REASONS FOR REISSUE

Fig. 2 - Cable Forms - Vertical and Horizontal Forms Serving Same Piece of Apparatus

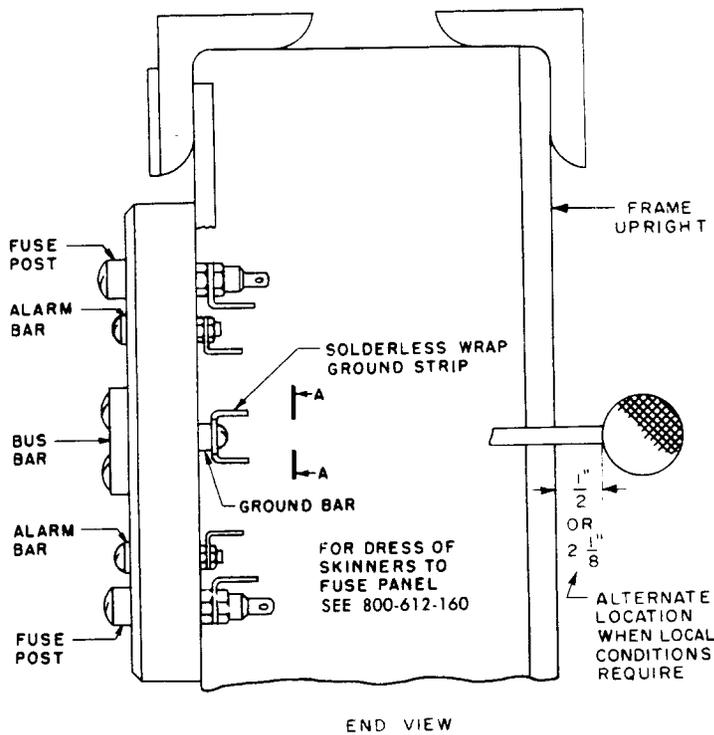
6. Various figures have been brought up to date to show presently manufactured equipment and apparatus.
7. Fig. 2 covering vertical and horizontal cable forms serving the same piece of apparatus is revised for clarity.

Fig. 4 - Frame Fuse Panel - 18- and Similar-Type Fuse Blocks - Bulb-Angle Frames

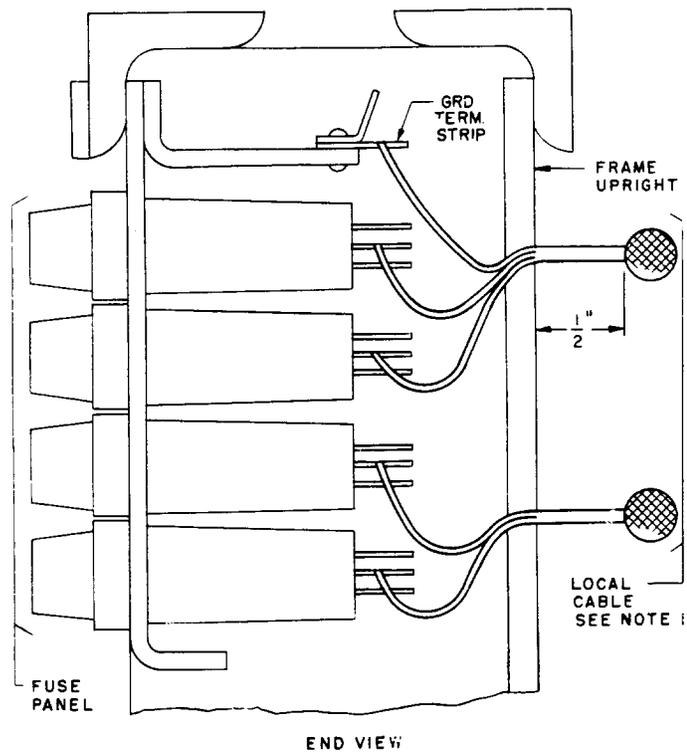
8. Fig. 4 covering 18-type fuse blocks on bulb-angle frames is revised to reduce the clearance from 3/4 inch to 1/2 inch between the frame upright and the local cable arm.

Fig. 5 - Frame Fuse Panel - 35-Type Fuses - Loose Wiring - No. 5 Crossbar

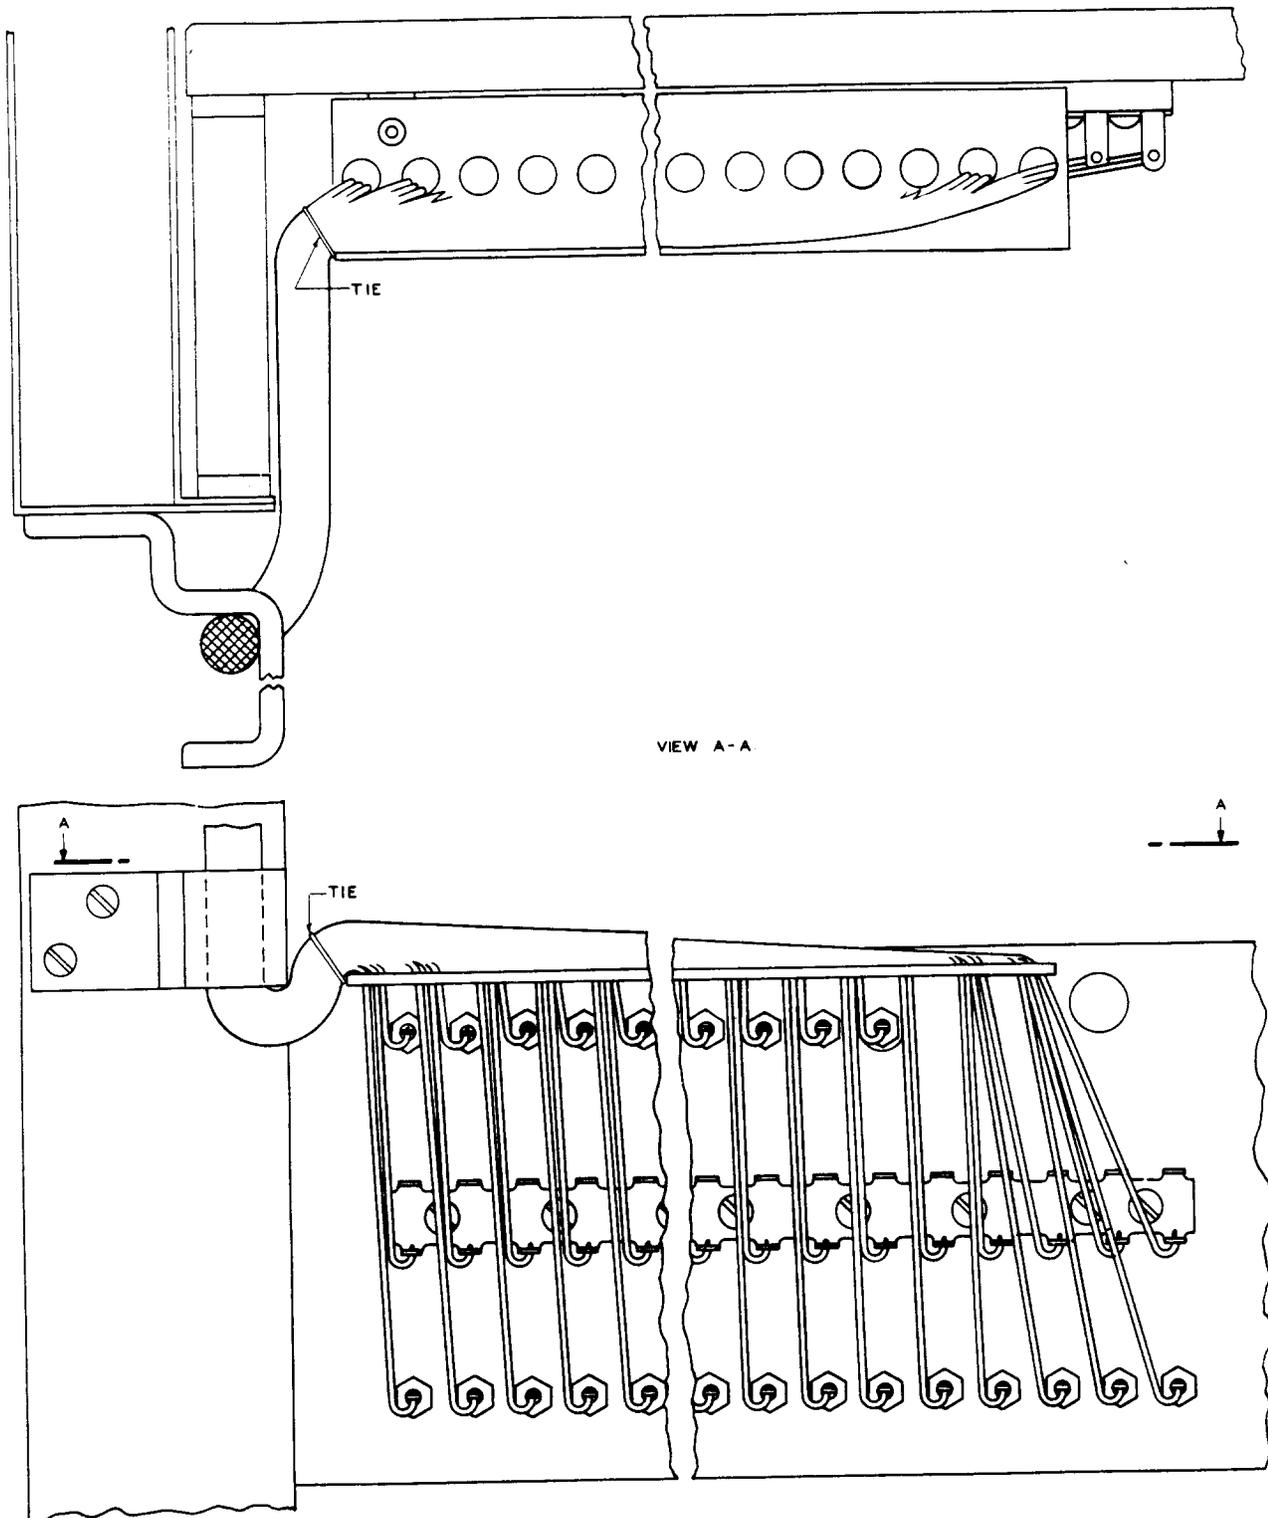
3. 2.04 covering loose wiring on No. 5 fuse panels is revised to omit "crossbar relay rack" frames and add "power ringing and tone distribution" frames.

Fig. 6 - Frame Fuse Panel - 21- and Similar-Type Fuse Blocks -
Local Cable - No. 5 Crossbar

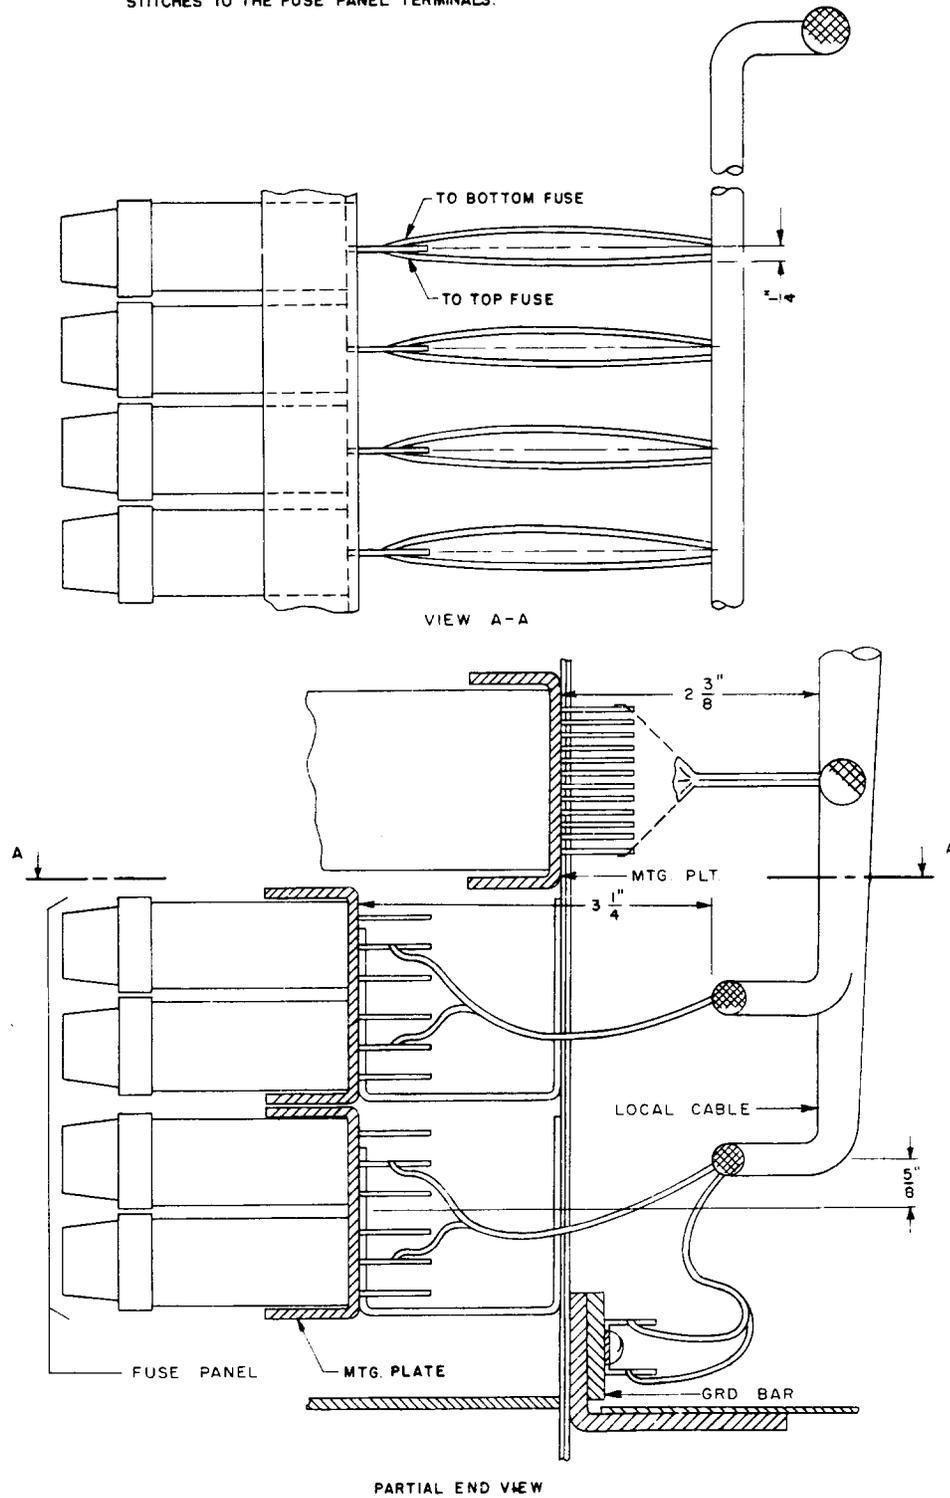
9. Fig. 6 covering 21- and similar-type fuse blocks is revised to move the lower local cable breakout arm up 5/8 inch from the center of the lower mounting plate.

Fig. 9 - 286-Type Relays - Multicontact - BT6A and BU6A Terminal Strips - Arrangement of Multiple Strap Wire Assembly

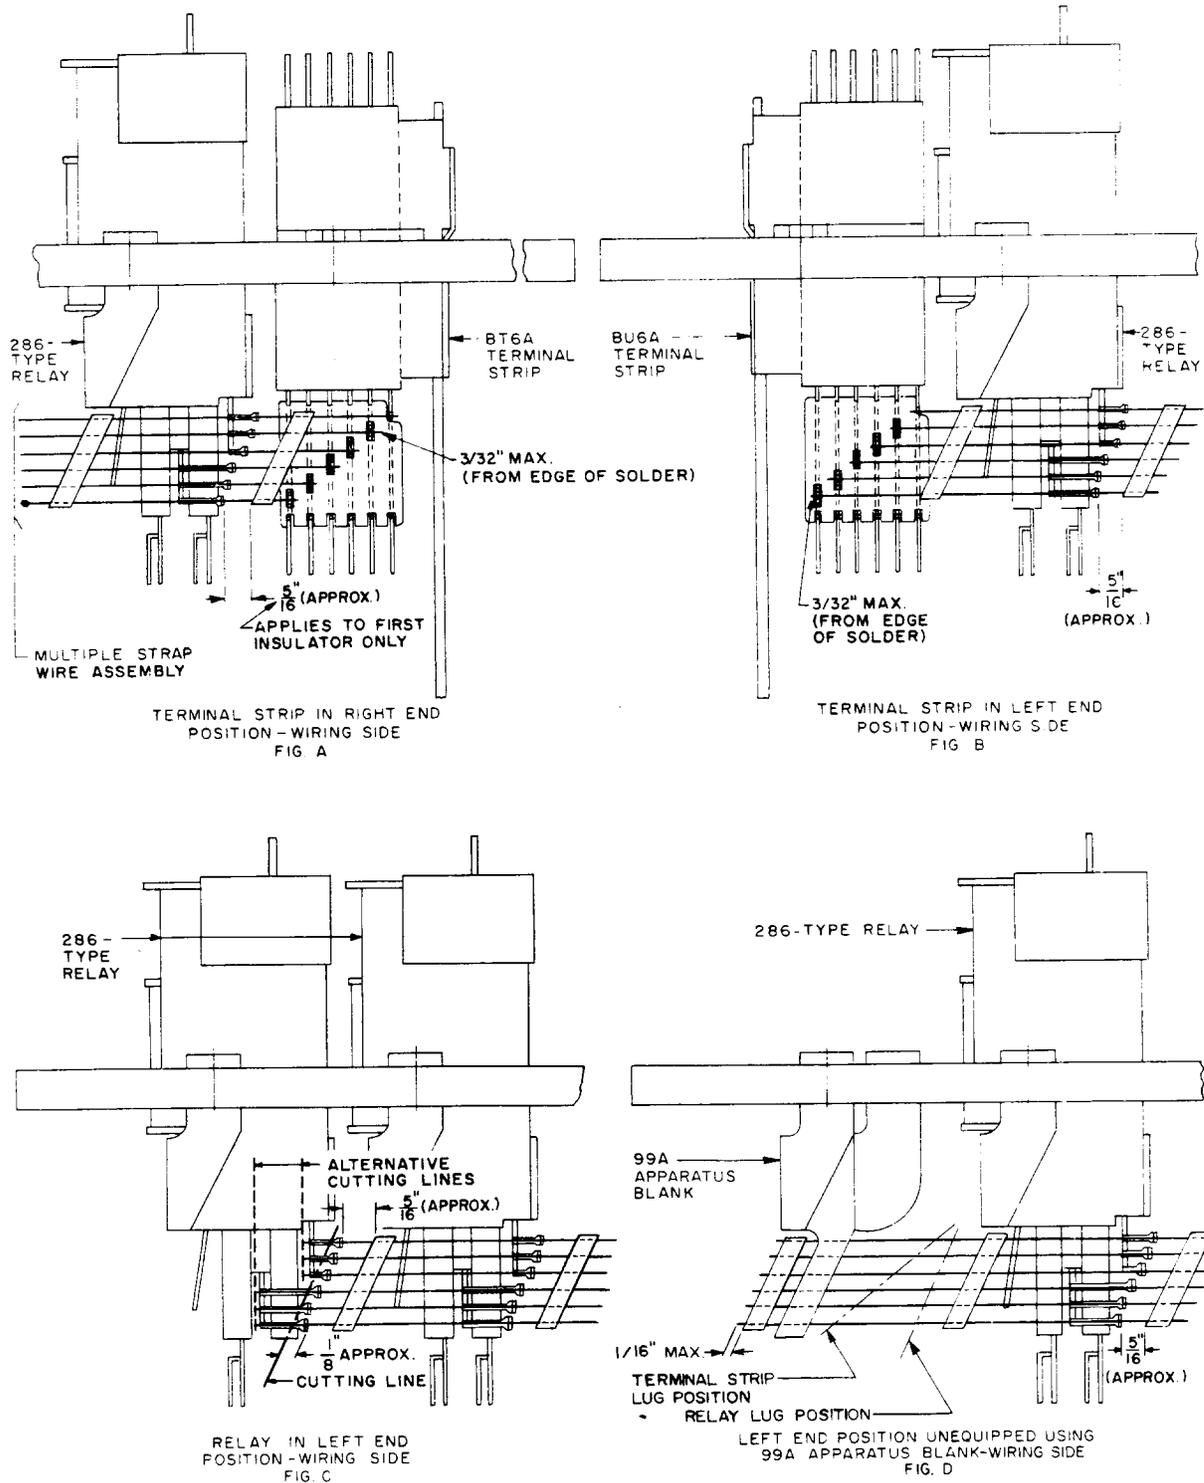
10. Former Fig. 9 through 15 covering wiring on 263- and similar-type relays are omitted because of no further application.
11. Fig. 9 through 11 covering multiple strap wiring on 286-type relays are revised to change the distance from the edge of solder to the end of the multiple strap from 1/16 to 3/32 inch.

Fig. 12 - 286-Type Relays — Multicontact — 180A Networks — BT6A and BY6A Terminal Strips — Local and Switchboard Cable Wiring

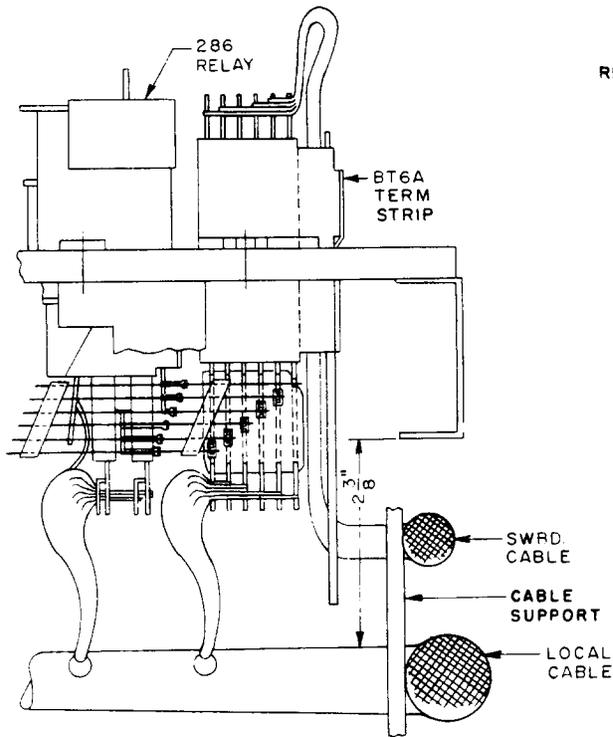
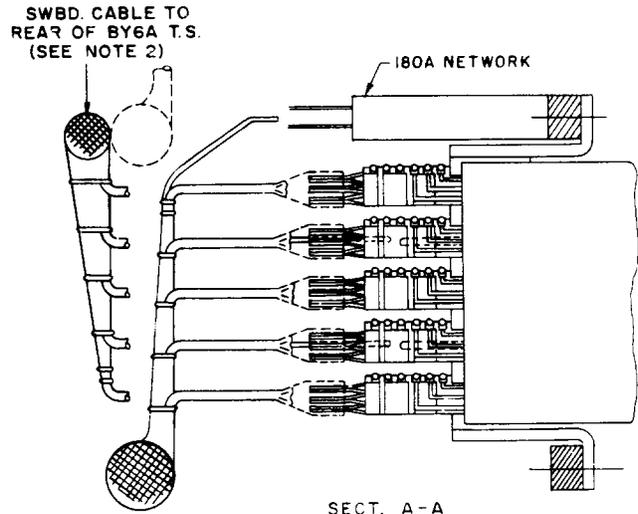
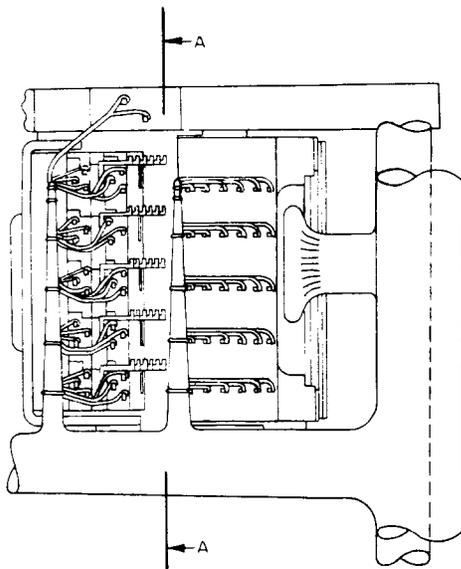
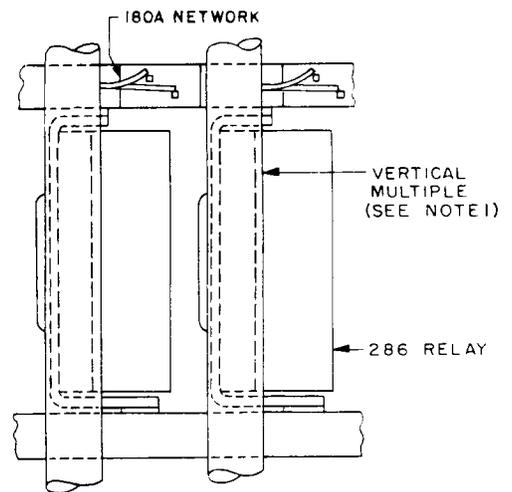
12. Fig. 12 covering wiring to 286-type relays is revised to clarify note 2.
13. Fig. 23 covering horizontal straps on 287- and similar-type relays is revised to add note 2.

Fig. 29 - 324- and Similar-Type Switches — (wrapped-type terminals) —
Single Horizontal Main Form

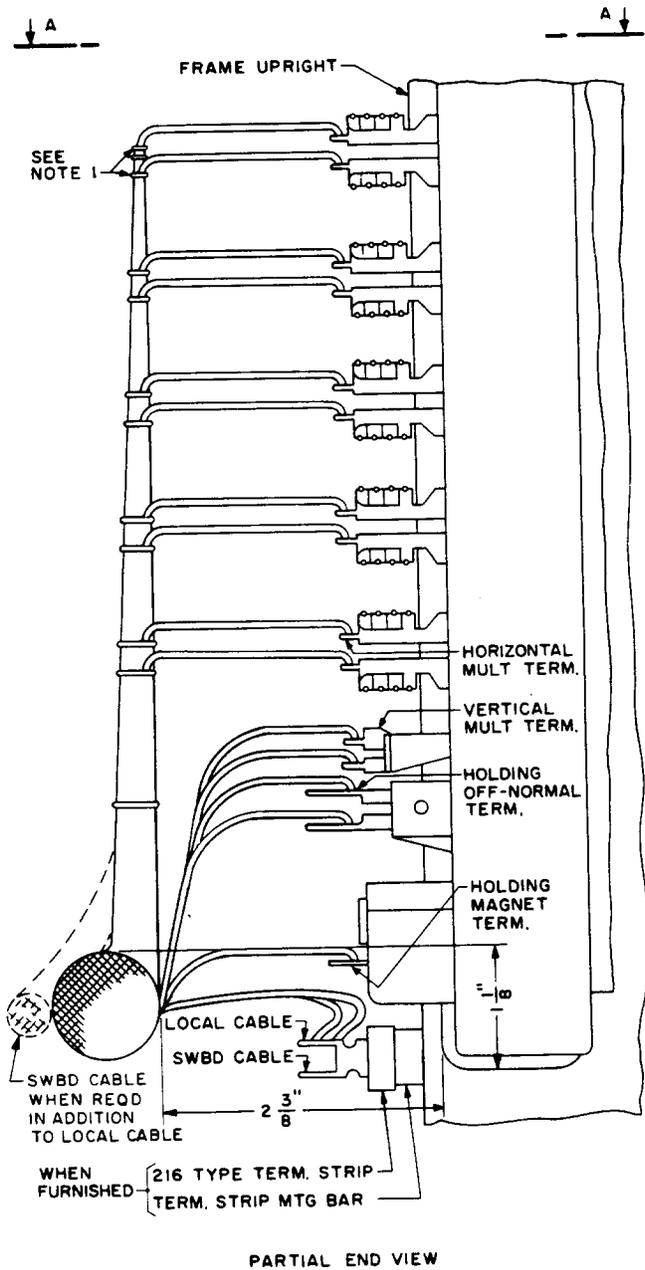
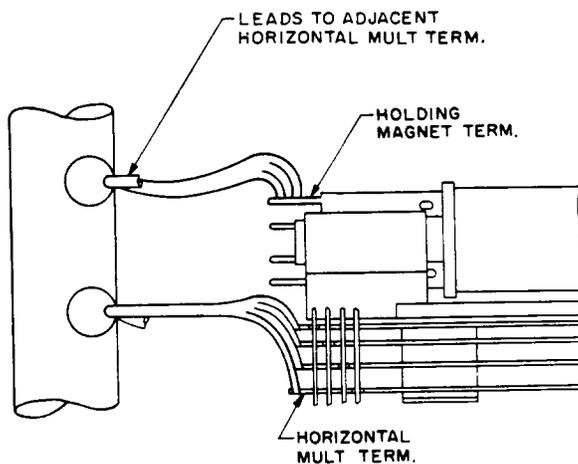
16. Fig. 29 covering wiring to 324- and similar-type switches is revised to change the lead dress and add reference to switchboard cable when required.

Fig. 30 - 324- and Similar-Type Switches — (wrapped-type terminals) — Wiring to "0" and "1" Level Terminals

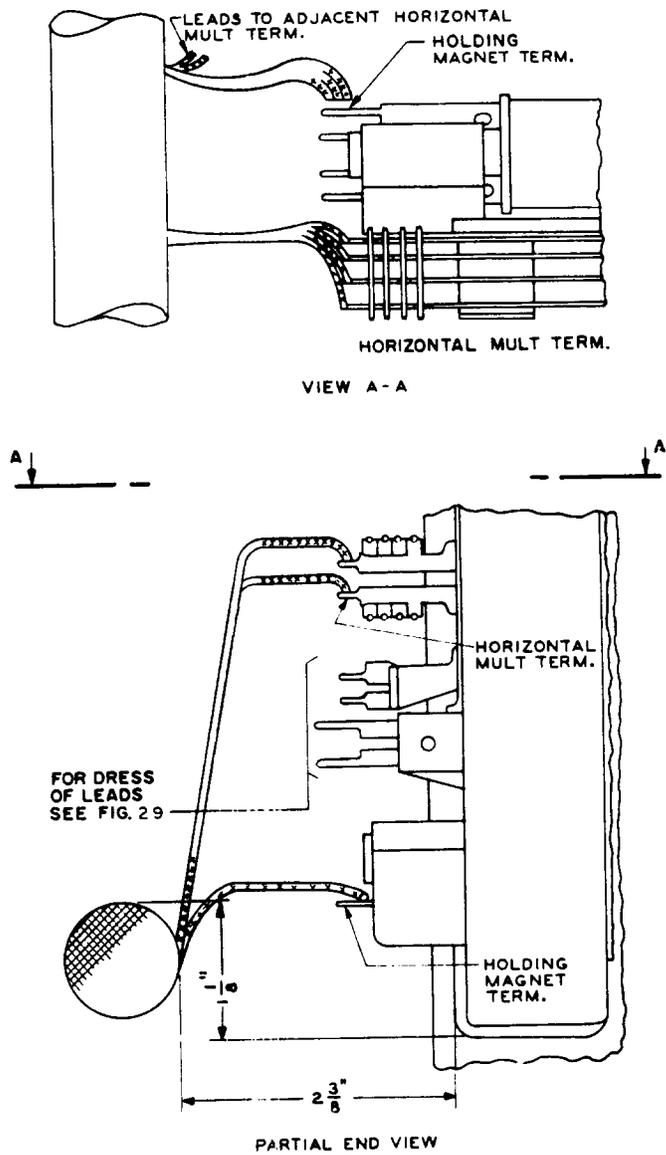
17. Fig. 30 covering wiring to 324- and similar-type switches is revised to change the lead dress.
18. Fig. 31 covering the wiring to the select magnets of 324-type switches is revised to add a method of dress on the select off-normal terminals.

Fig. 34 - 324- and Similar-Type Switches — (wrapped-type terminals) — Strapping of Switch Vertical Units

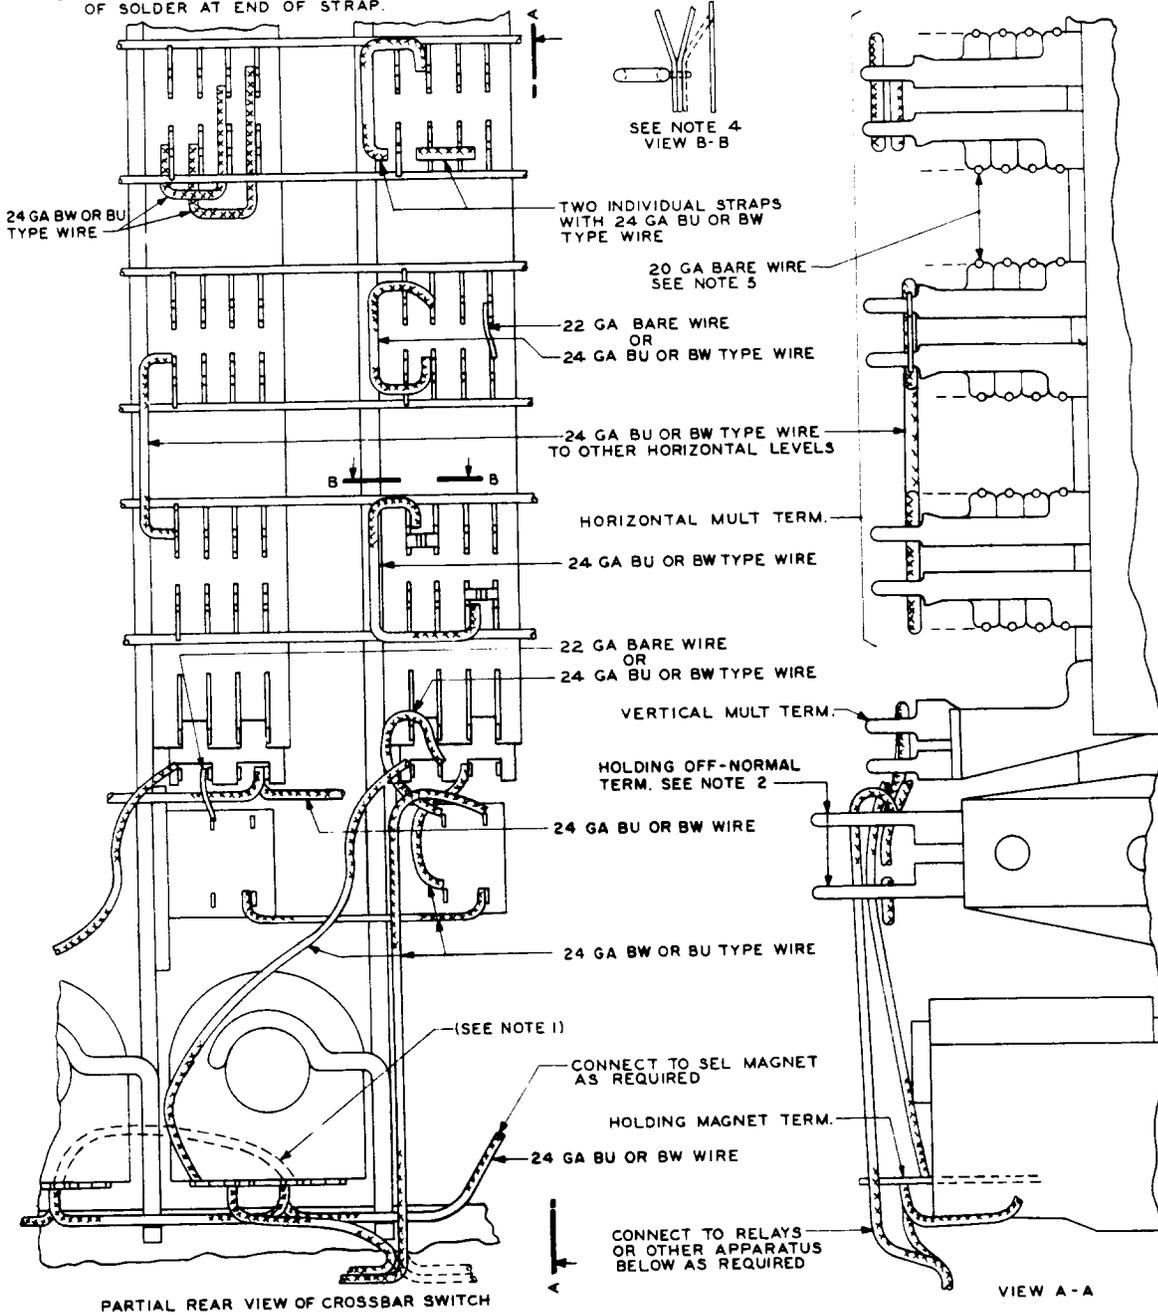
19. Fig. 34 covering vertical strapping on 324- and similar-type switches is revised to omit the bare wire strap on the hold off-normal terminals, to add note 1, and to add an additional method of strapping crosspoint terminals.
